PROPOSED TECHNICAL SPECIFICATION CHANGES

9207150022 920709
PDR ADOCK 05000368
P PDR

FIGURE 3.6 - 1

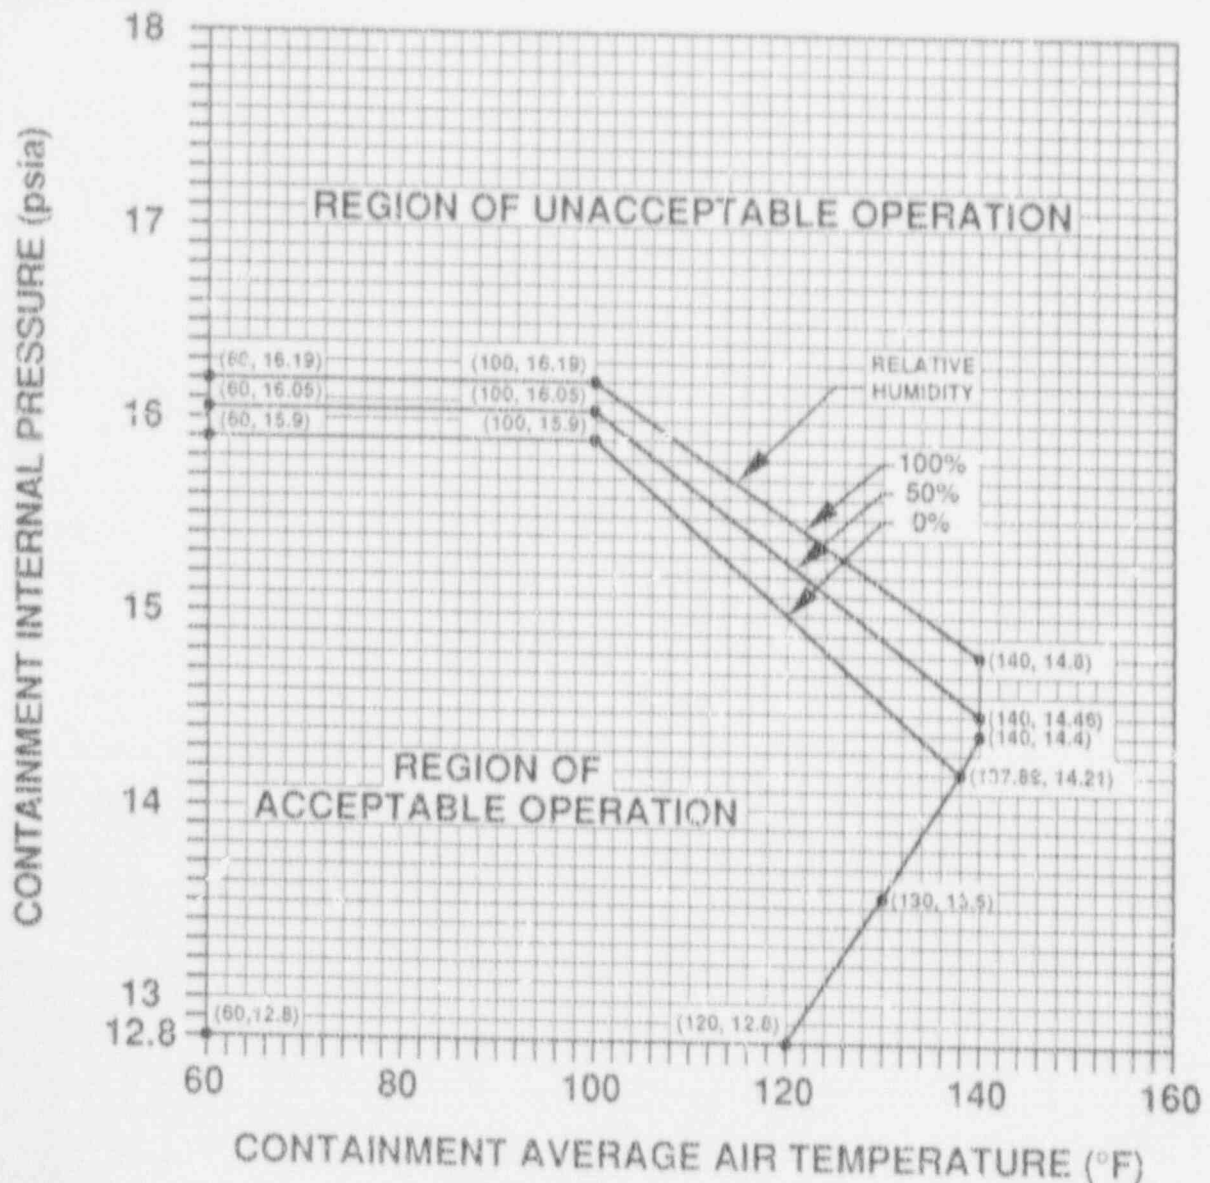
The limitation on containment average air temperature ensures that the containment liner plate temperature does not exceed the design temperature of 300°F during LOCA conditions. The containment temperature limit is consistent with the accident analyses. Figure 3.6-1 represents analysis limits and does not account for instrument error.
